DRAFT SUMMARY OF INTERIM REMEDIAL INVESTIGATION JANUARY 1987 THROUGH  
APRIL 1989 NAS FORT WORTH TX  
8/1/1990  
RADIAN CORPORATION

Review of Hargis and Associates, Inc. (1989):

Summary of Interim Remedial Investigations,  
January 1987 to April 1989,  
U.S. Air Force Plant 4,  
Fort Worth, Texas

Radian Corporation  
8501 Mo-Pac Boulevard  
P. O. Box 201088  
Austin, Texas 78720-1088

Figure 9-A. Alternate Contouring of Water Level Data Posted on Figure 9 (Hargis, 1989)

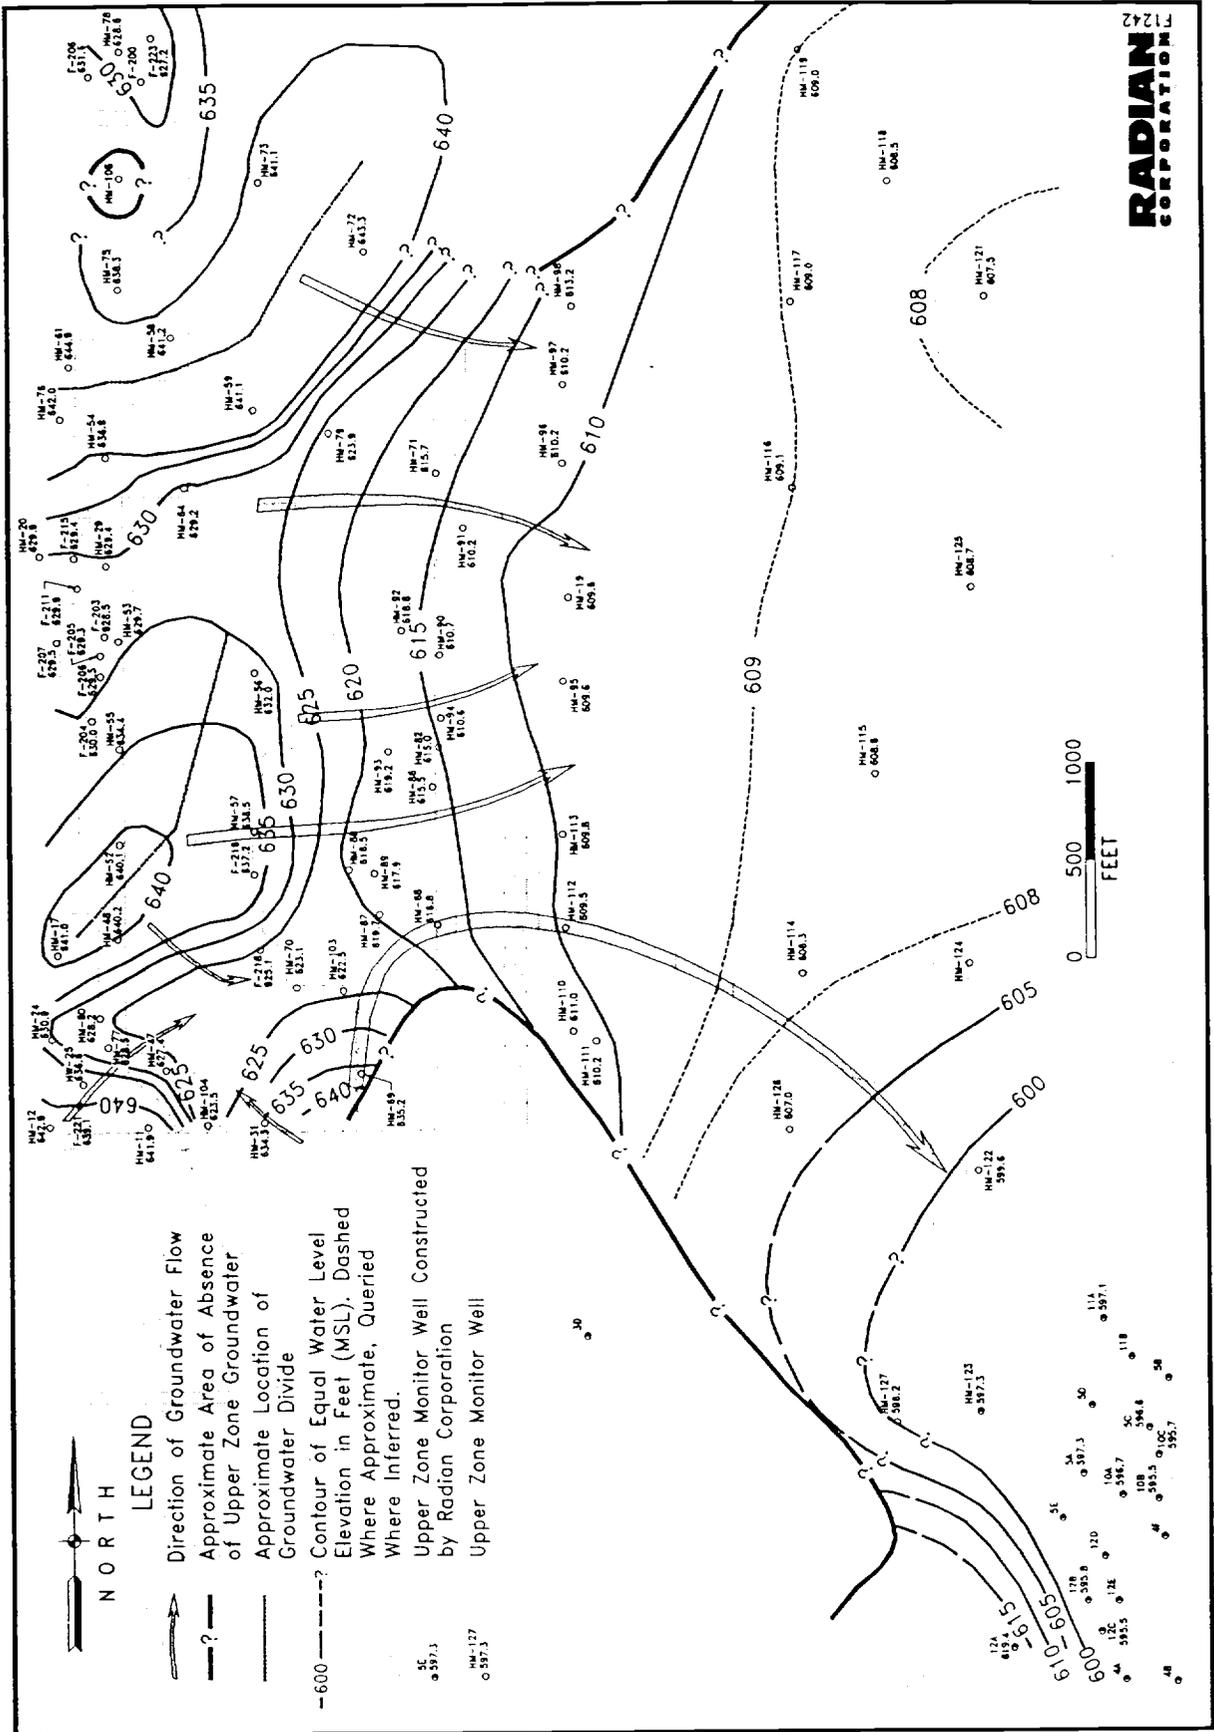
The potentiometric surface interpreted by Hargis (Figure 9) is erratic in the vicinity of the assembly building suggesting either numerous points of recharge or contouring of non-representative data (see preceding discussion). Aside from precipitation, potential sources of recharge identified by Hargis include broken water mains, sewer lines, and storm sewers. The relatively high hydraulic gradients in this area are consistent with Hargis' conclusion that bedrock topography influences ground-water flow direction and rate in the Upper Zone, since the bedrock surface is steeply dipping in this area (Figures 4 and 5). East of the assembly building, the water table exhibits less variability and the hydraulic gradient is lower, consistent with the locally flatter bedrock topography.

Notwithstanding the uncertainties surrounding the representativeness of the water level data, the ground-water flow directions shown on Figure 9 appear reasonable insofar as they tend to follow the bedrock topography, especially the eroded bedrock channels and permeable channel fill deposits of the Upper Zone. Also as shown on Figure 9, Hargis interpreted the existence of a northeasterly-trending ground-water divide beneath the Plant 4 assembly building. In the position indicated, such a ground-water divide could potentially inhibit or prevent ground water on the west side of the assembly building from migrating eastward, toward Carswell AFB. However, even if the posted water levels are taken at face value, the potentiometric surface in this area can be alternately contoured as shown in Figure 9-A. In that situation, ground water west of the assembly building could flow eastward beneath the Plant 4 engineering office building. As shown by Hargis on Figure 16, a plume of trichloroethylene (TCE) centered on monitor well HM-29 could potentially migrate eastward along this flow path.

Figure 14-A. Alternate Contouring of Total Chromium Data Posted on Figure 14 (Hargis, 1989)

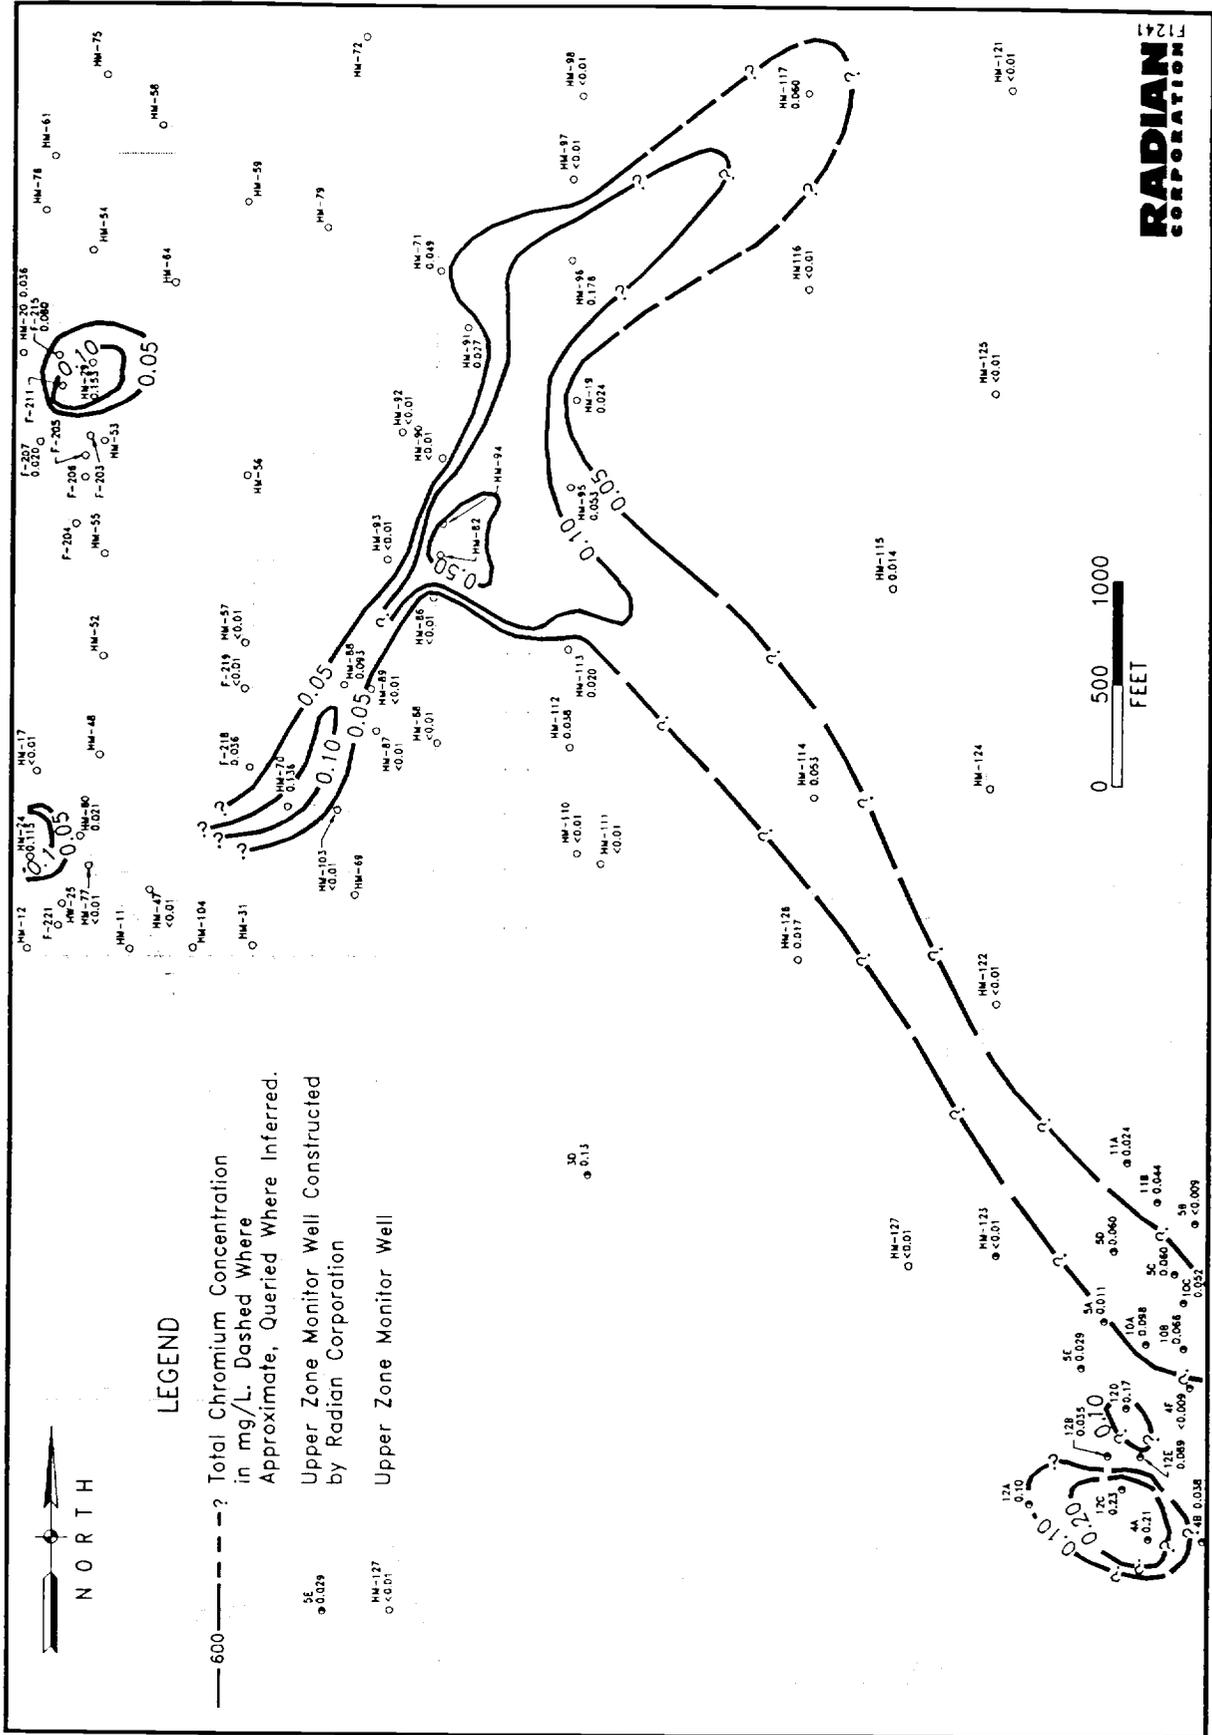
Figure 14 shows the estimated areal extent and concentration distribution of chromium contamination in Upper Zone ground water as interpreted by Hargis. The contoured chromium concentrations are from samples collected during two separate events approximately one year apart (April 1988 versus April 1989), with all 1988 data from wells on Carswell AFB. As previously noted, any interpretations based on data from two such temporally distinct events are highly speculative.

The plume configuration shown on Figure 14 of Hargis suggests chromium is migrating from the east parking lot area of Plant 4 to the northeast and southeast along the two eroded bedrock channels (previously

Chromium was also detected in Upper Zone ground-water samples collected by Radian from monitor wells located just east of the Carswell AFB flightline. Hargis suggests (p. 25) that the chromium detected in the Carswell wells is from a different source than the chromium in ground water beneath Plant 4 based on "the distribution and concentration of total chromium in water samples collected from these (Carswell AFB) wells," and contours the Carswell data separately. However, the distribution of data points is extremely sparse east of runway 130. Because of this, chromium data could be contoured alternately. By extrapolating the 0.05 ppm isoconcentration contour to encompass sampling points on the Carswell AFB flightline (monitor wells 5C, 5D, 10A, 10B and 10C), the existence of a continuous plume, extending from a source(s) on Plant 4, beneath the runways, to the Carswell AFB flightline area could be interpreted (Figure 14-A). The orientation and configuration of this projected plume also corresponds closely to the southeasterly-trending bedrock channel that may be a preferential pathway for contaminant migration (see discussion at Section 5).
